Draft Wilton Town Centre Precinct Rezoning

Draft Wilton Town Centre Precinct Rezoning

Wilton Junction
 Water Cycle Management Strategy
 Photo Locations
 Revision: B Dated 30/05/14

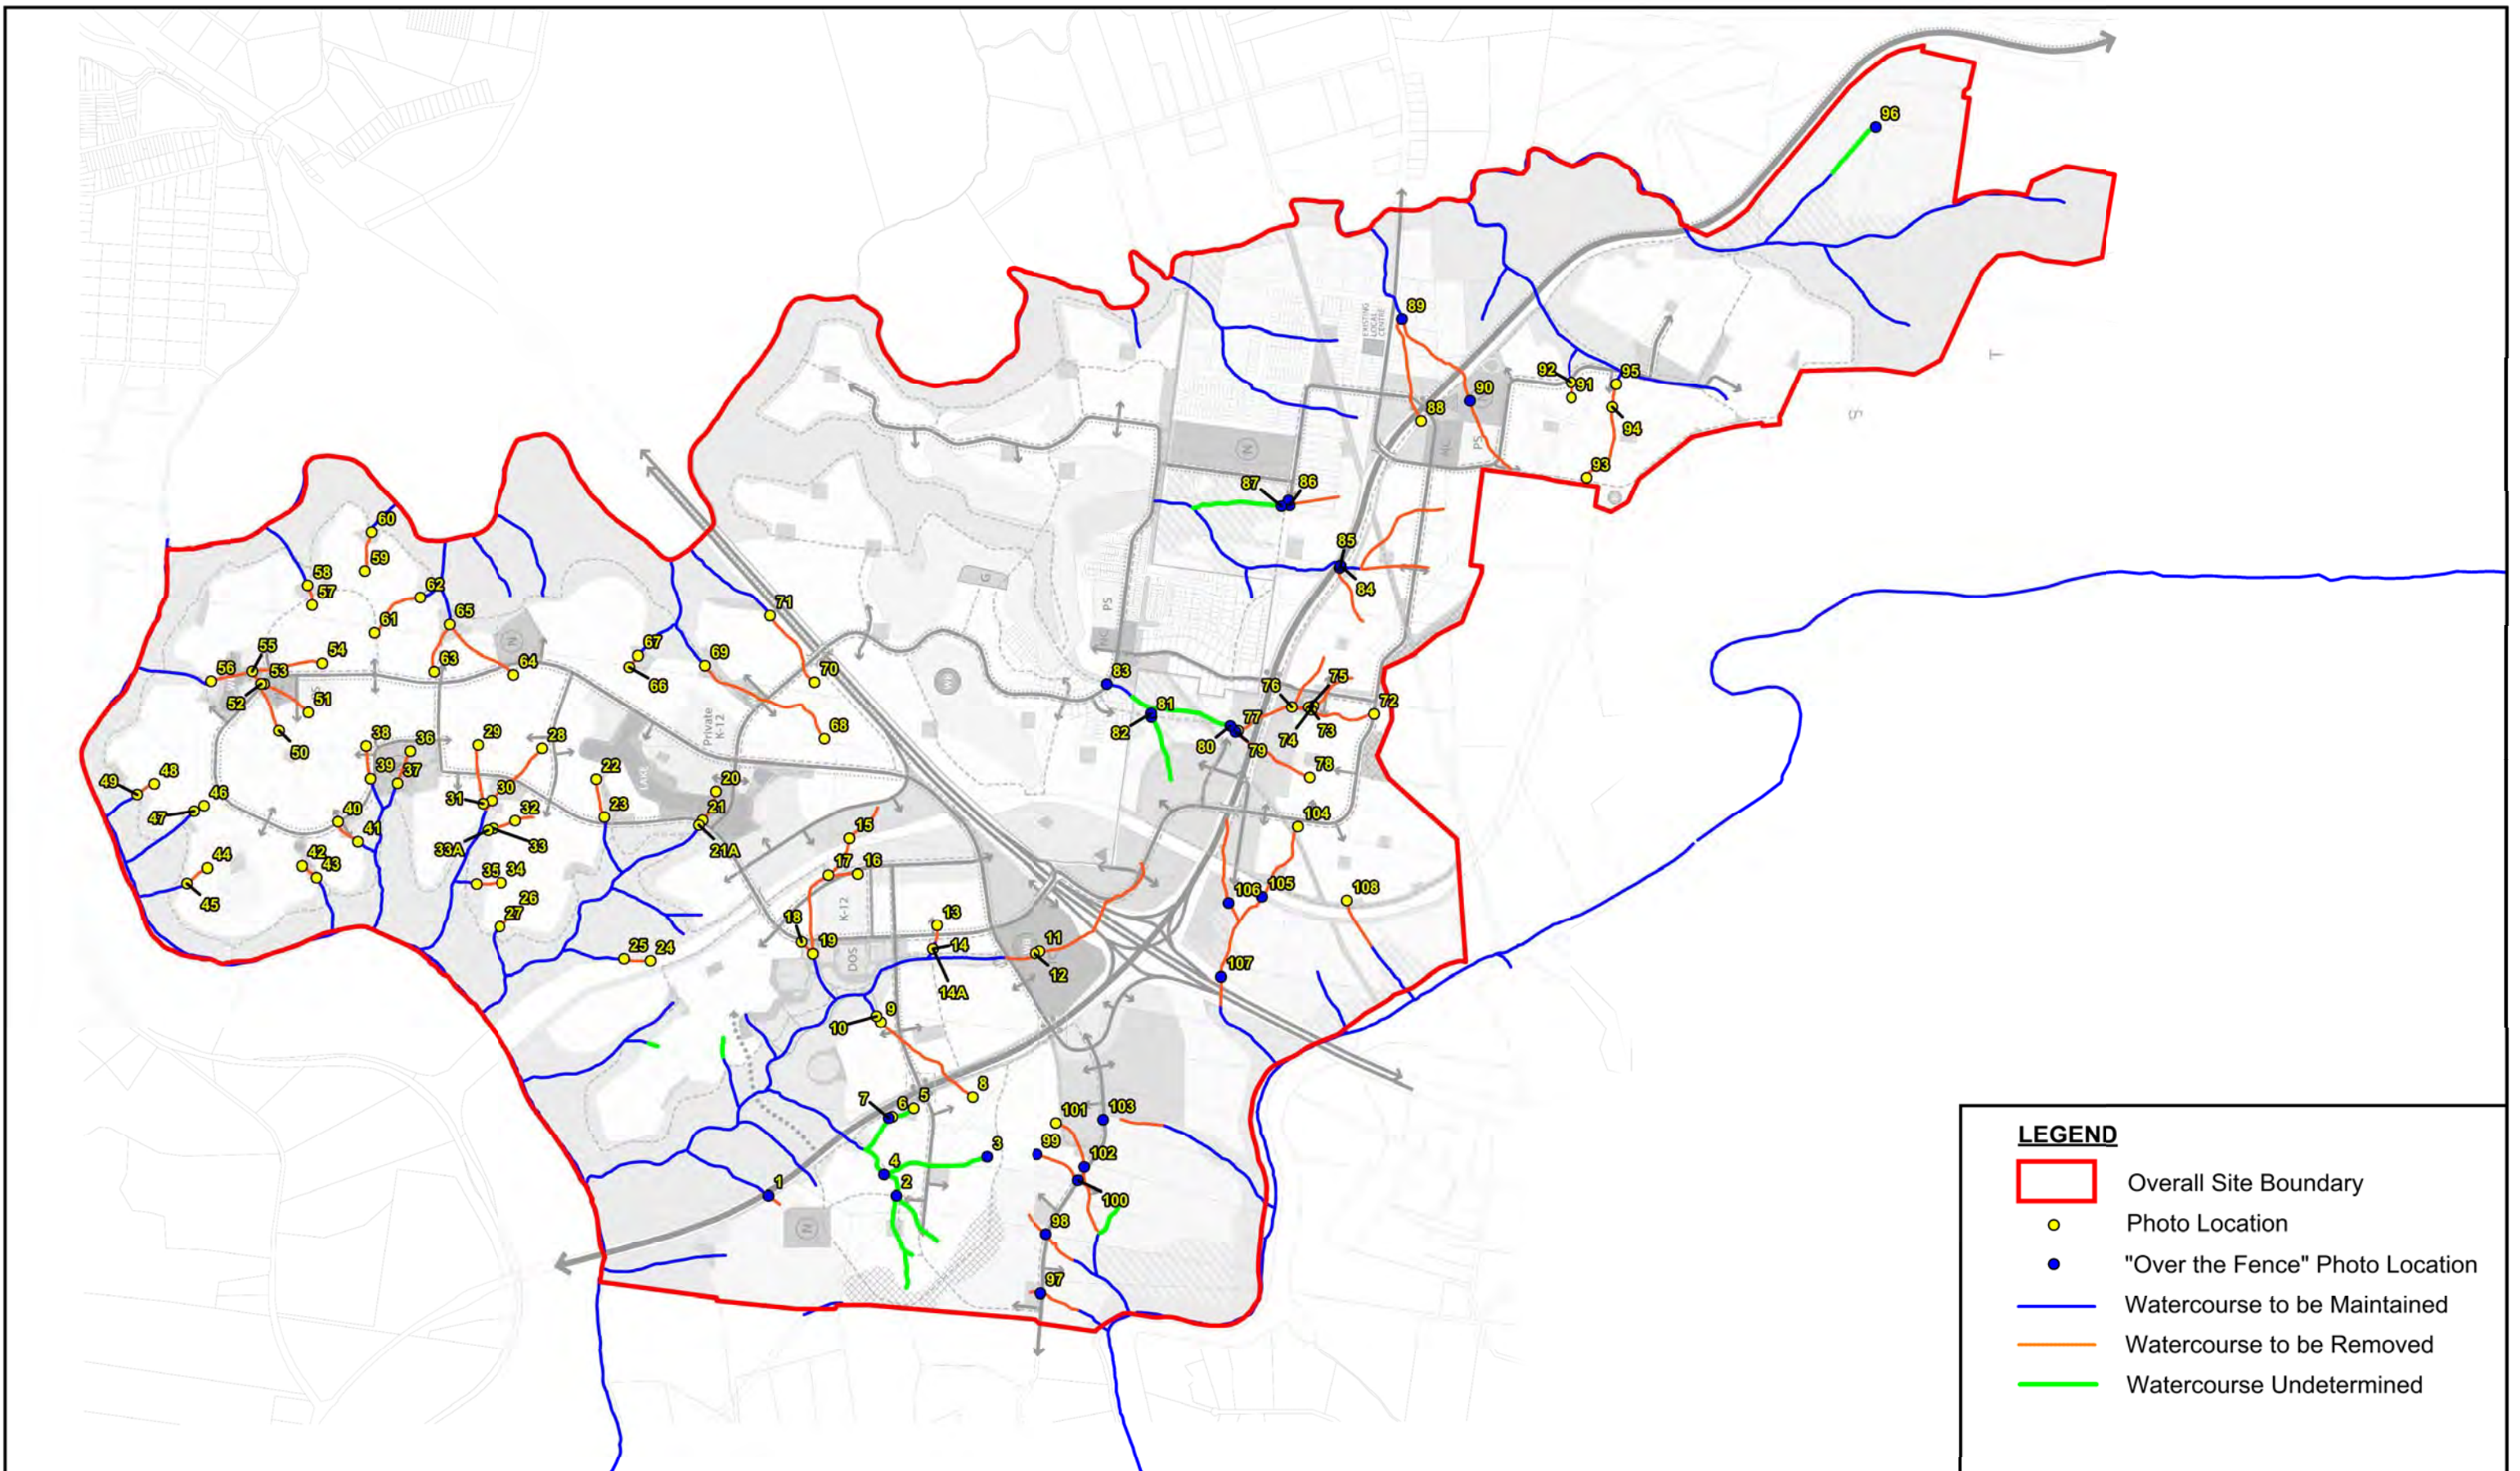
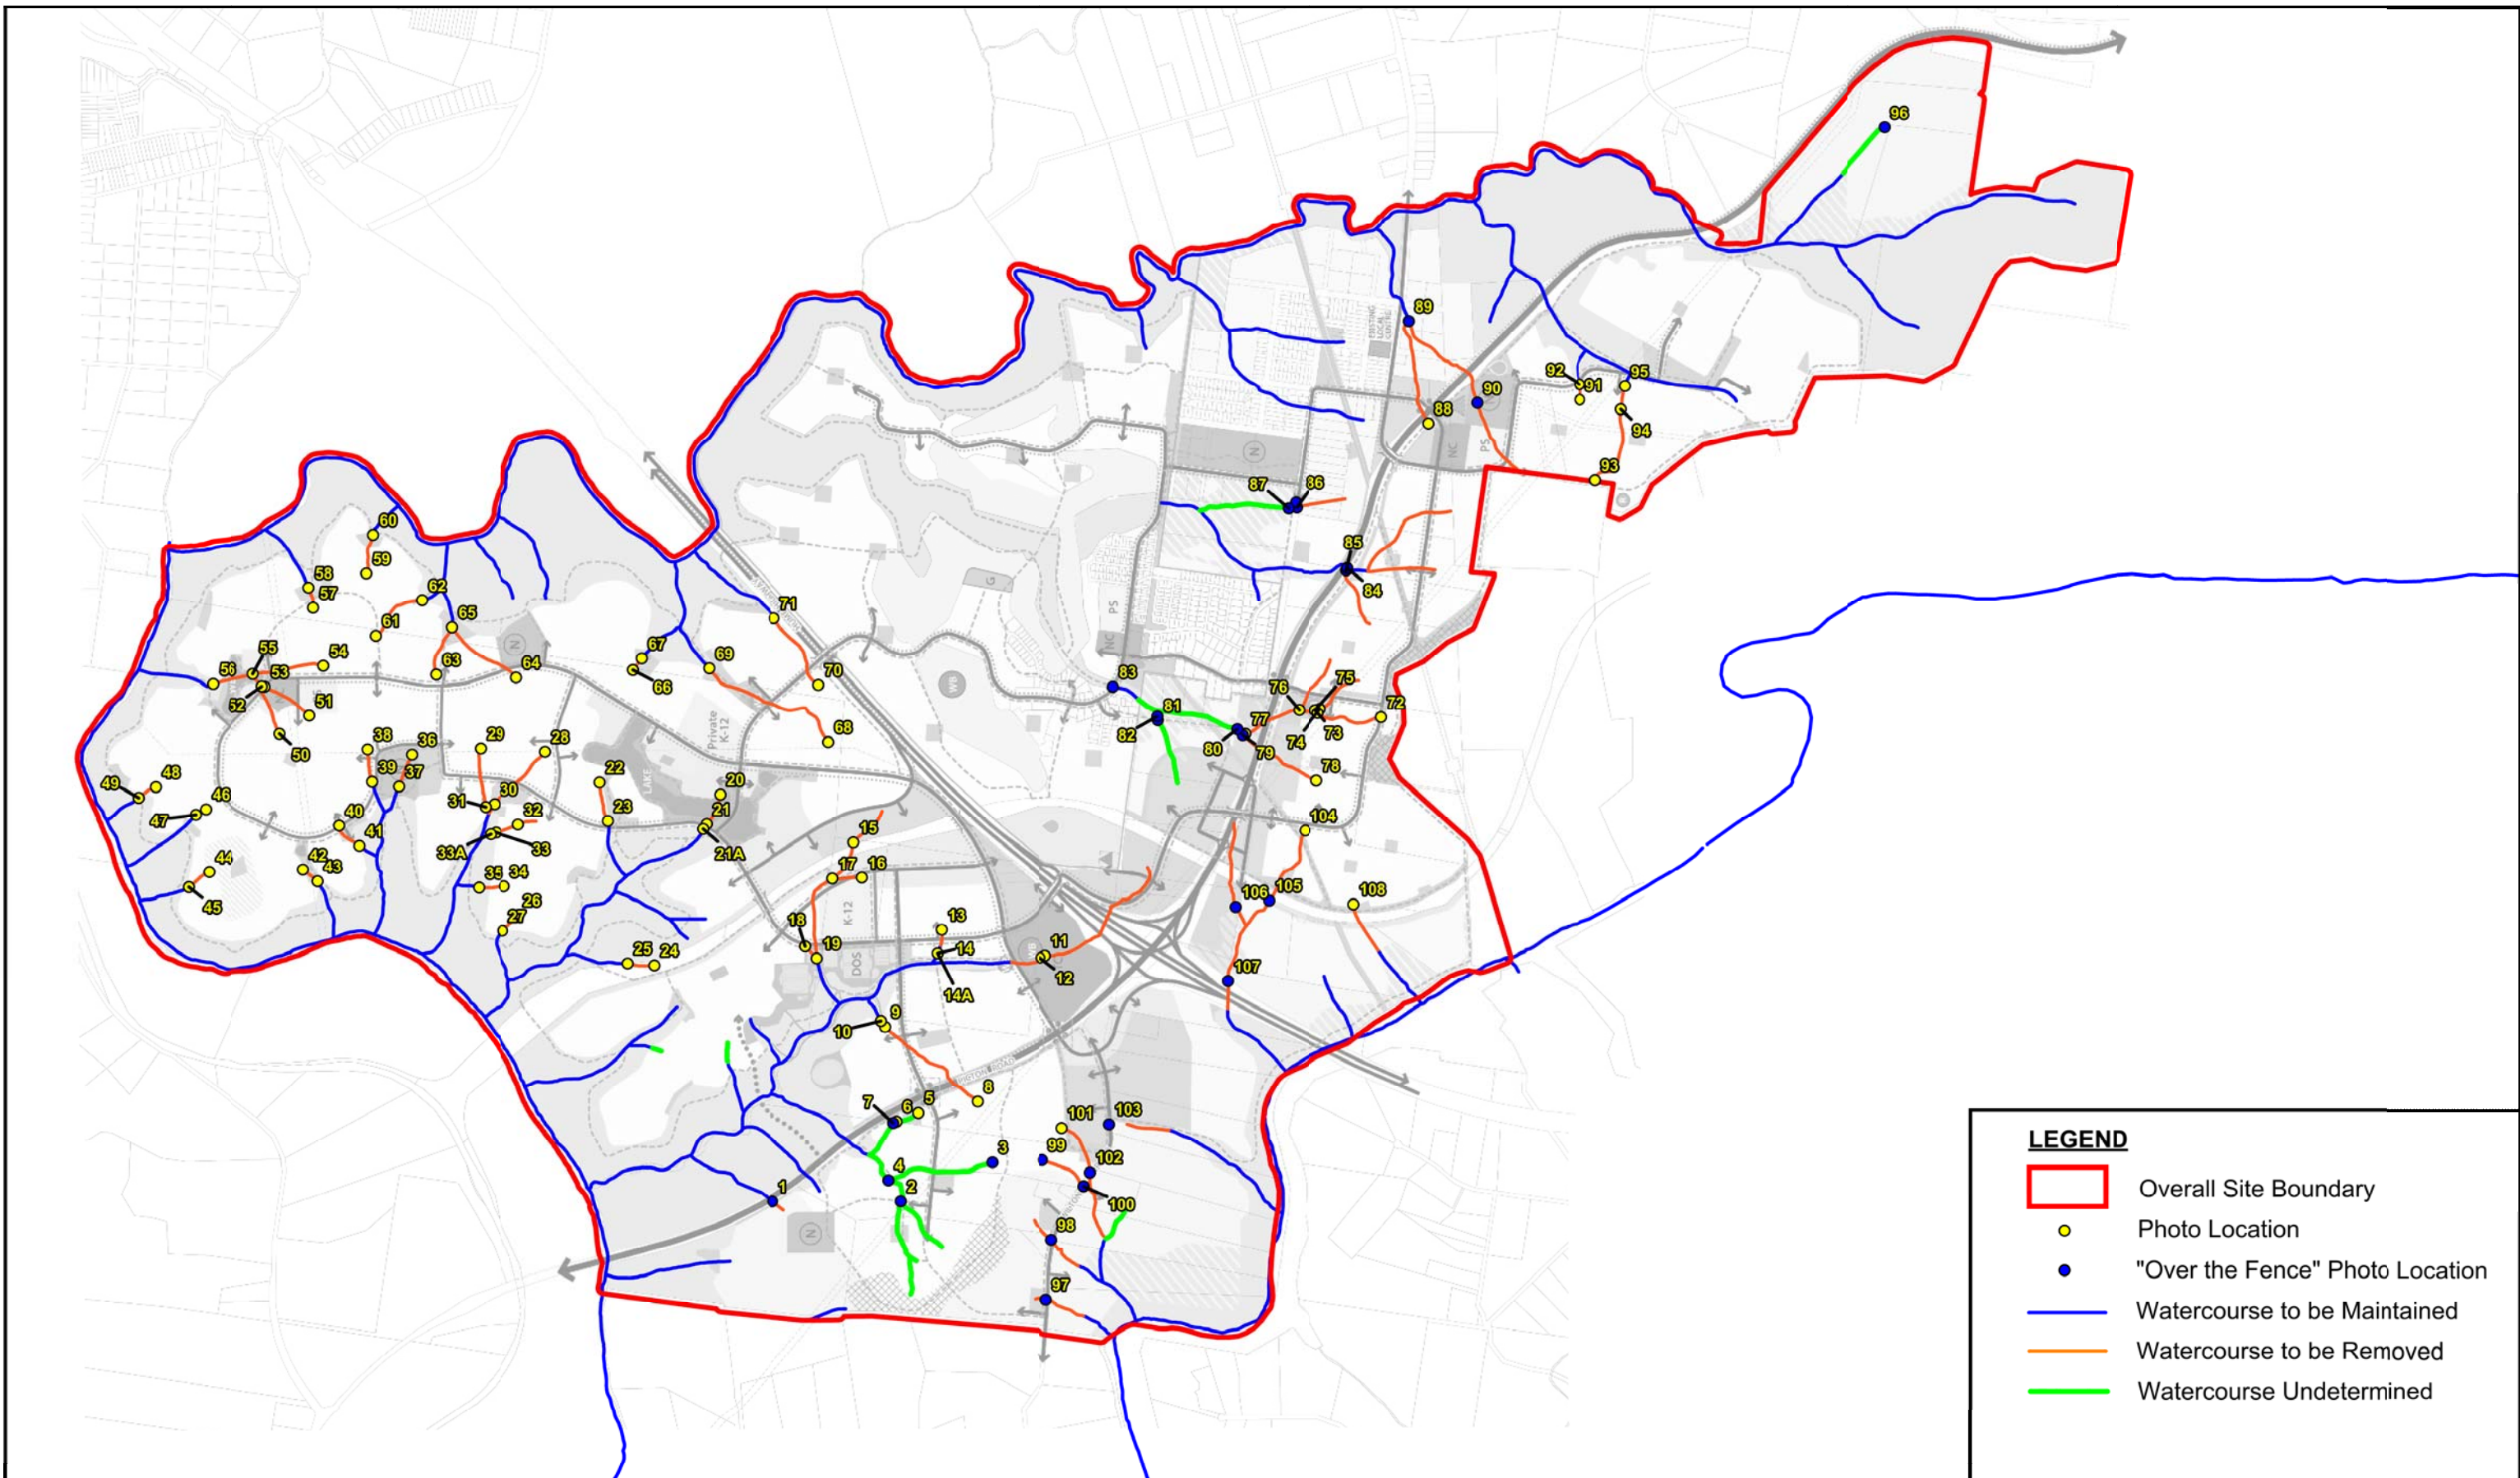
Water NSW agreed to the determination of water courses 15 to 19 and 50 to 56 in Figure 13 as not being waterfront land and can be removed.

The map provided in Figure 13 identifies watercourses to be retained or removed. The figure shows the retention of a number of reaches determined not to be rivers within the stream assessment report. Further clarification is required within the report to confirm whether all retained watercourses as defined by blue lines in Figure 13 will be managed as Waterfront Land in accordance with the NSW Office of Water Riparian Corridor guidelines.

Streetscape outcome (Rouse Hill) as a result of alfresco dining areas directly at kerb edge. It impacts visual quality of the place and pedestrian movements and connections

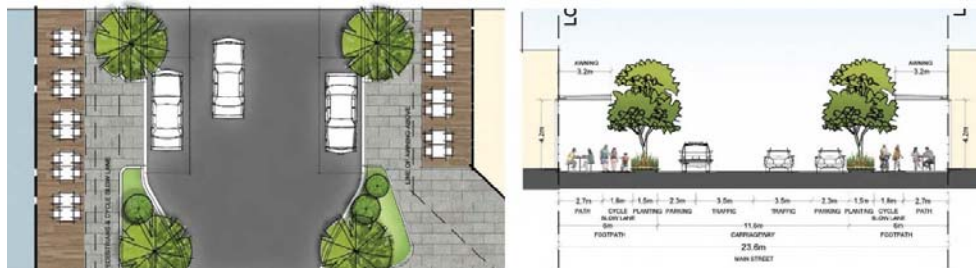
- **Figure 13** requires alfresco dining areas in the main street to be located directly abutting traffic and parking lanes. Locating alfresco dining along the kerb of a road is not conducive to creating a comfortable and inviting dining experience: it;

- Creates security problems for the tenancy by the need to manage a dining area and customers that are separated from the tenancy by a busy pedestrian thoroughfare;
- Encourages tenancies to erect illegal barriers along the kerb edge to enclose the space, separating it from the street to address these issues. This results in a poor streetscape outcome as illustrated by the recent photograph of the Rouse Hill Centre below.

(Original Map top, Suggested changes to map below)

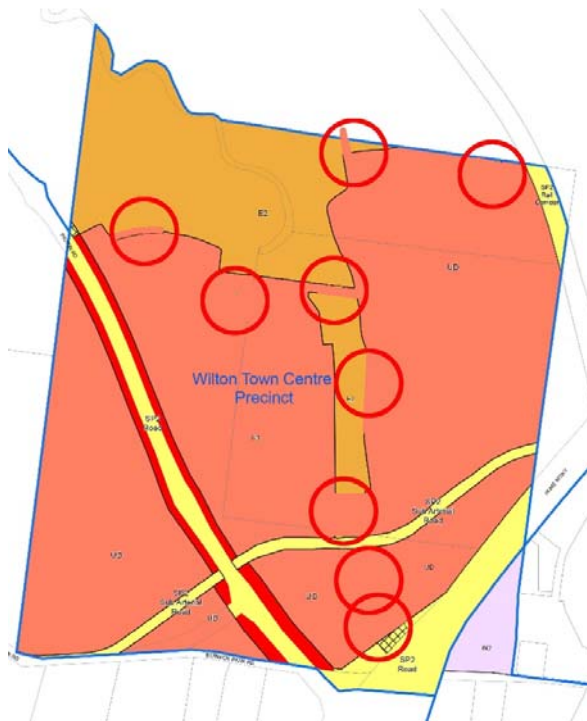
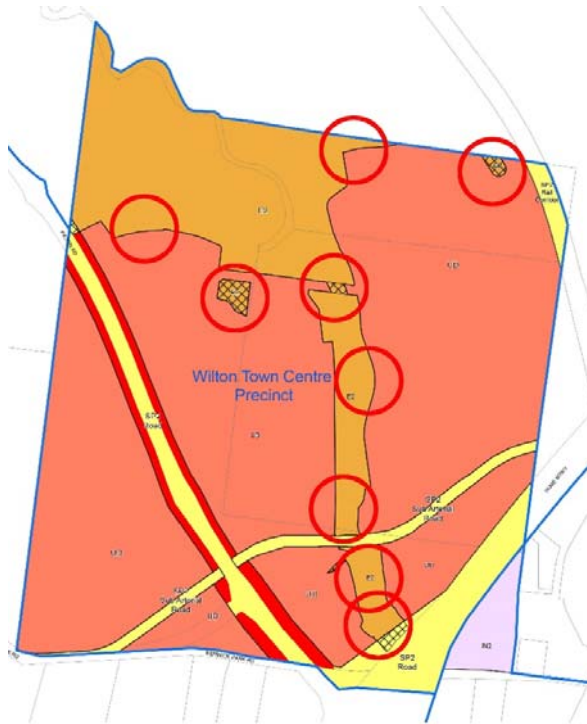
Changes Requested to Zoning map

Figure 1: Comparison between Rezoning Proposal (left) and Structure Plan (right) road alignments in the south-western portion of the Town Centre Precinct with contour overlay

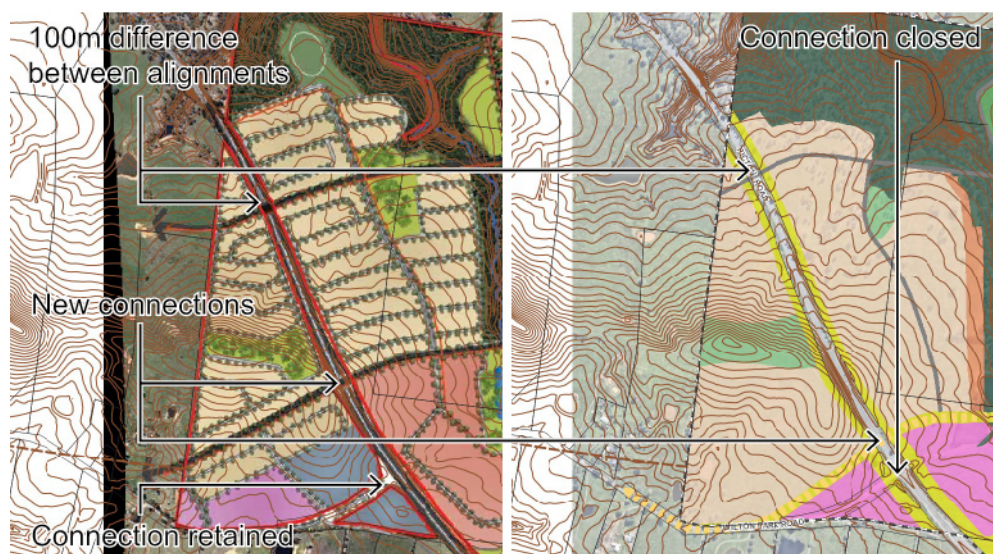
As shown in **Figure 1**, the exhibited Structure Plan and supporting DCP documents differ to the Planning Proposal specifically in terms of the alignment of future roads connecting the Town Centre to the West Wilton Precinct.

Accordingly, the Rezoning Proposal should be updated to reflect the exhibited Structure Plan, or struck from the list of exhibited documents such that it cannot be relied upon should the proponent wish to vary the Structure Plan at DA stage.

Figure 2 Part 7 Wilton Town Centre DCP application area

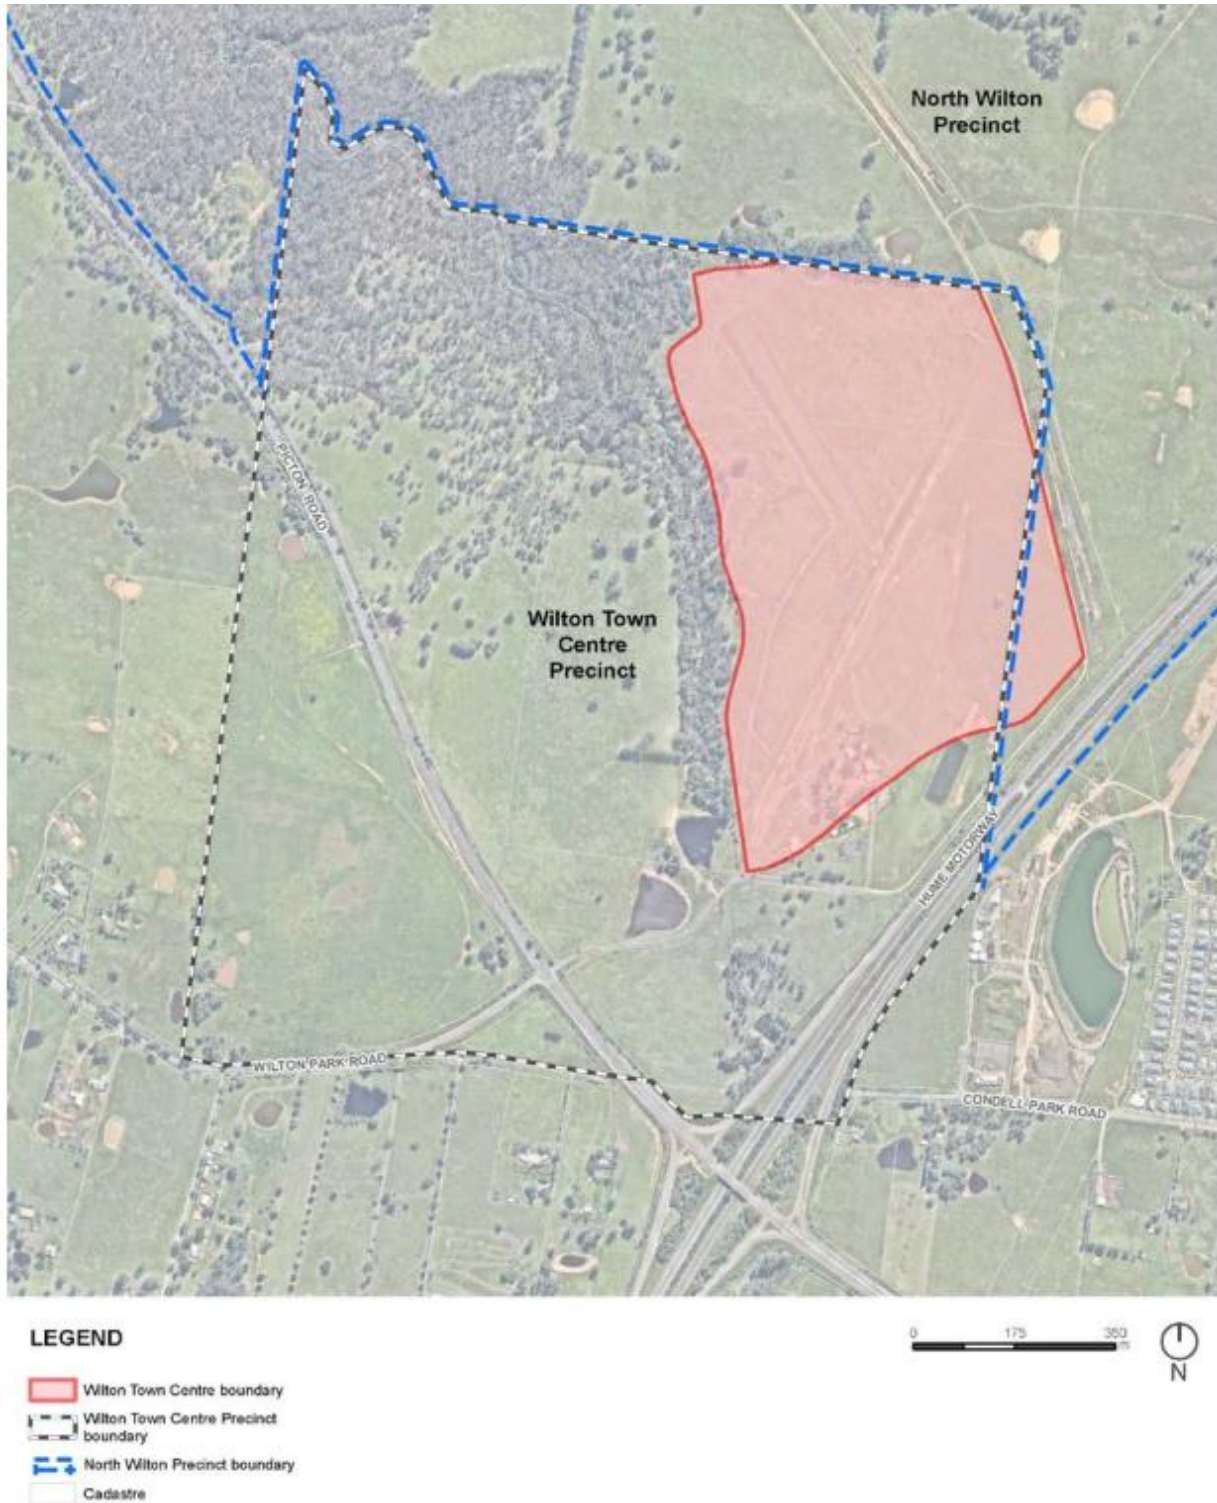
Part 7 Wilton Town Centre applies to the area between the MDRC and the north south riparian corridor and includes land within the North Wilton Precinct (see Figure 2). However, draft Part 7 of the DCP only applies to land within the Town Centre Precinct. Further clarification is needed on the application of the DCP
